PERFORMANCE BULLETIN

3150/3900 Drive Switch Clearance with New Drive Cam

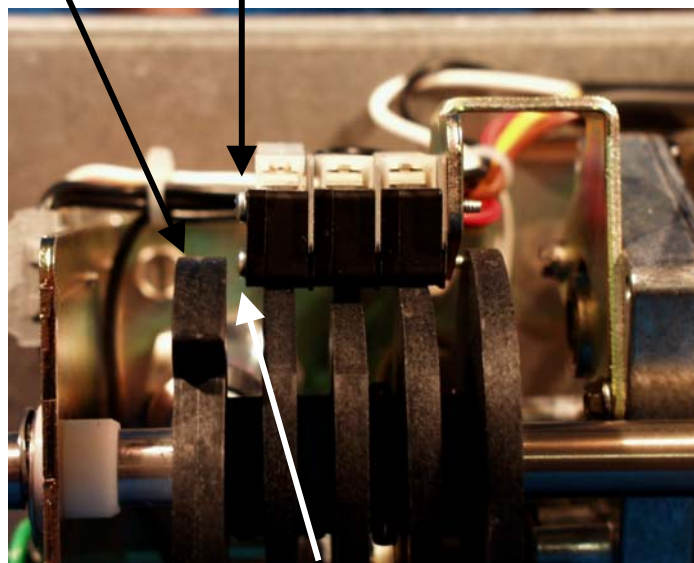
In April 1998, we made an improvement to the 16494-drive cam assembly. The brine cam lobes¹ are .100" thicker to open the 1800-brine valve for brine draw and brine tank refill. In order to make the screw clearance² for the micro switches; we have eliminated the outside insulator³. All Fleck wiring harnesses are UL component recognized and do not require the additional insulator.

1. Brine Cam Lobe

3. No Insulator

2. Clearance
